DART SERVICE BULLETIN SB12-2

D407-797-011/-012/-013/-014 AND D206-797-021/-022/-023/-024 HELI-UTILITY-BASKET INSTALLATIONS AT CHANGE 003 OR EARLIER

REF TCCA STC: SH11-1 FAA STC: SR02996NY REF EASA STC: 10035429

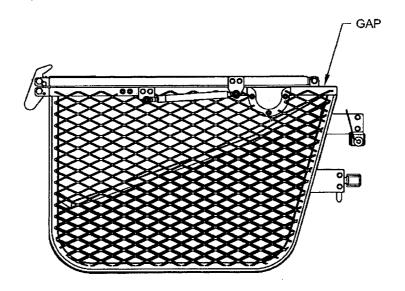
Dart Aerospace Ltd. has received information indicating that under certain circumstances on D407-797-011/-012/-013/-014 and D206-797-021/-022/-023/-024 Heli-Utility-Basket Installations at CHANGE 003 or earlier, thin flexible objects such as an unsecured retaining strap can find their way out of the basket through the narrow opening located along the top inboard side of the basket base assembly, and cause damage to the aircraft and/or depart from the basket in flight.

For operators with aircraft equipped with D407-797-011/-012/-013/-014 and D206-797-021/-022/-023/-024
Heli-Utility-Basket Installations at CHANGE 003 or earlier, it is recommended that the opening described above be closed off with D4672-1 Blanking Plates using the DSI 9620-011 Blanking Plate Kit per DSI 9620 Rev. A (or later approved revision).
